UNITED STATES PATENT AND TRADEMARK OFFICE

APPLICATION NO.	FILING DATE	FIRST NAMED INVENTOR	ATTORNEY DOCKET NO.	CONFIRMATION NO.
10/613,644	07/03/2003	Garrett Henley Barnes	0015-0001	4623

Office Action Summary

DETAILED ACTION

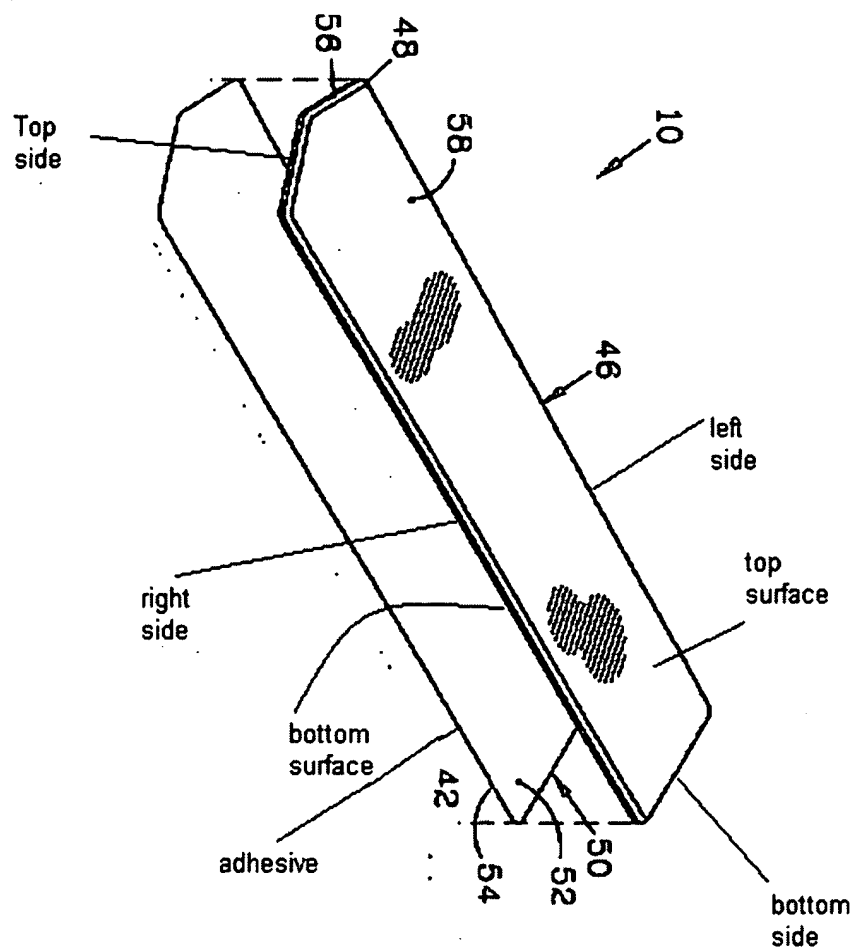
Holland discloses a disposable pad apparatus system (see figure below) for use with an associated backboard, the pad comprises at least three sides, further comprising a right side having a length about the length of the associated backboard, a left side having a length about the length of the associated backboard, a top side having a width about the width of the associated backboard, a bottom side having width about the width of the

associated backboard (please see fig 1 for having length and width of associated backboard and bottom figure for all the elements). The pad also has a top surface, a bottom surface has an adhesive mechanism (52) attached thereto, the adhesive mechanism is used to releasably attached the pad apparatus system to the associated backboard. Holland further discloses a cushion material, examiner has interpreted to be the pad of Holland, since the cushion material is between the top surface and the bottom surface.

With respect to claims 2, 13, and 24, Holland discloses a adhesive mechanism (column 8 lines 49-56), which the examiner has interpreted to be equivalent to the “peel and stick” tape.

With respect to claims 4, 14 and 25, the adhesive of Holland is capable of facilitating peeling by the way of having a two-sided adhesive (50).

With respect to claims 5, 16 and 27, the adhesive of Holland is attached to the whole bottom surface of the pad.

With respect to claims 8, 10, 19, 21, 30, and 32, Holland discloses a top surface with indicia, such as a line (60) to form a pad indexing mark that facilitates visual alignment of the pad with the upper surface of the backboard and to align the pad, which is interpreted as having print on the top surface as required by the claims.
